2019 PROPOSED IMPROVEMENTS

EXHIBIT B

IV. Fort Lauderdale Beach Parking Lot

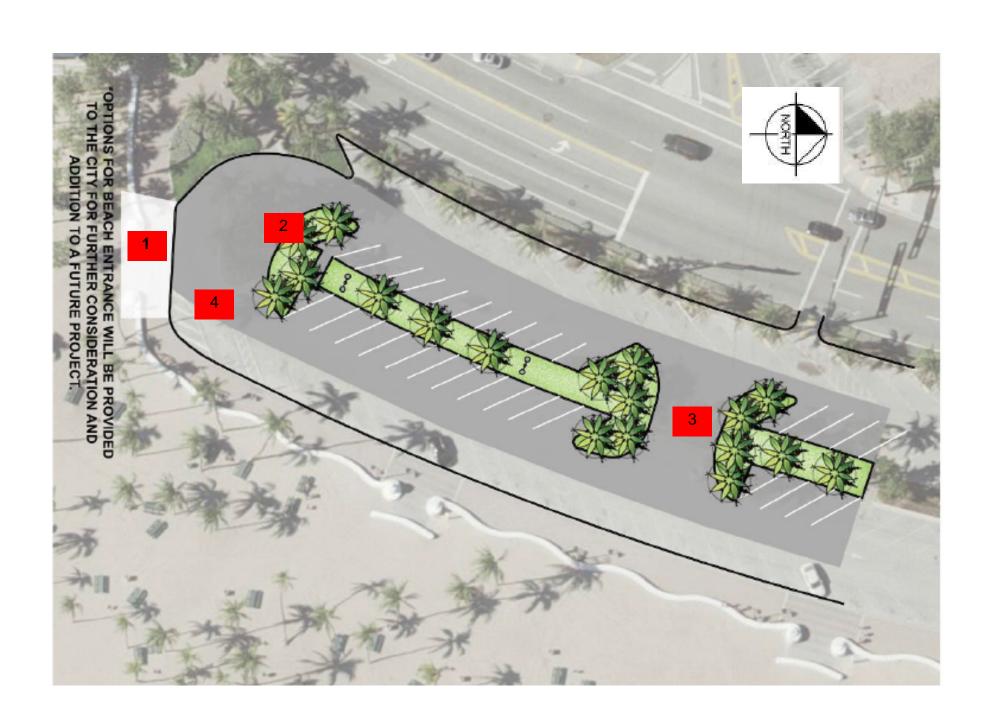
Proposed curb/median cut in parking lot

Events staging area. Will be blocked off from public during events.

Proposed curb cut on A1A

Proposed median cut for truck/car u turns' in parking lot.

Area for expansion of water/sewer/electrical lines for beach events (concerts, volleyball matches, etc)

Eliminated due to conflicts with the traffic and FDOT refusal. Also it will be to expensive due to the arm.

Eliminated as there in no single point of connection that will benefit all the events and the existing water and sewer connections can be used as needed. All the events have different configurations that will require different points of service.

Electrical connection for the south side to be coordinated with FP&L during design.
